# BCA ASSESSMENT REPORT

*Dapto Leagues Club*

Project Number: 118133

Revision: 2.1

Figure 1: Level 2 plant room only contains plant and therefore is not counted in the rise in storeys as per C2D3(2)(a). New roof area in yellow is the new Porte Cochere connecting from the club building to the new car park building.

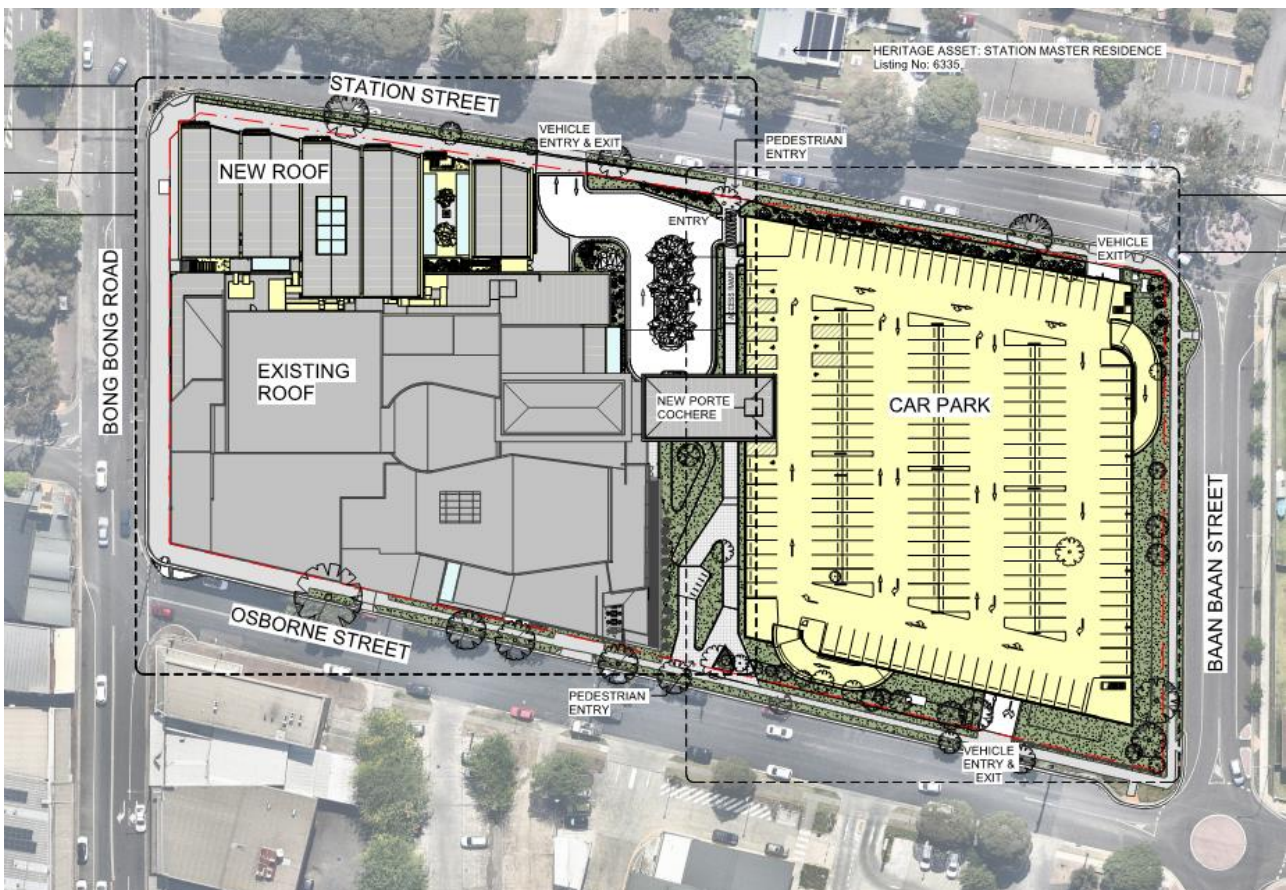
The proposed development includes a new Porte Cochere covered area to connect between the club building and the car park building. Refer to Figure 1 below. This is considered to create a connection between the two buildings, thus creating one united building. However, the two buildings will be assessed as separate buildings via a Performance Solution. Whilst acknowledging the Porte Cochere provides connection between the buildings, the Performance Solution will rationalise the omission of fire walls to separate buildings as noted under Clause C3D8 due to the open nature of the Porte Cochere and assess the building as separate buildings under the provisions of BCA 2022.
